Independent Environmental Audit Report

Waratah Super BESS

August 2024

Project Number: 230681

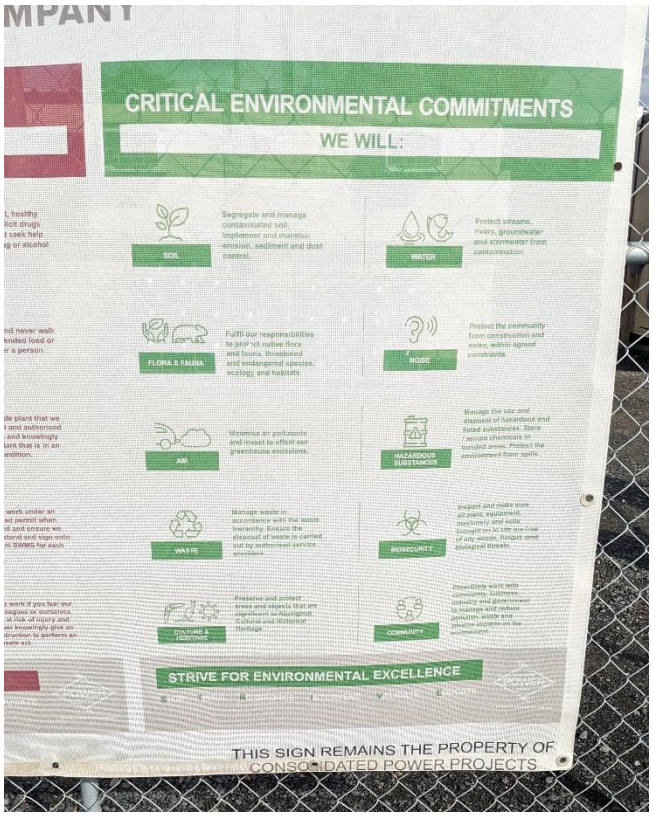
Turbid water observed in the western roadside drain leading to Hammond Canal, resulting from coreholes in the existing weir structure
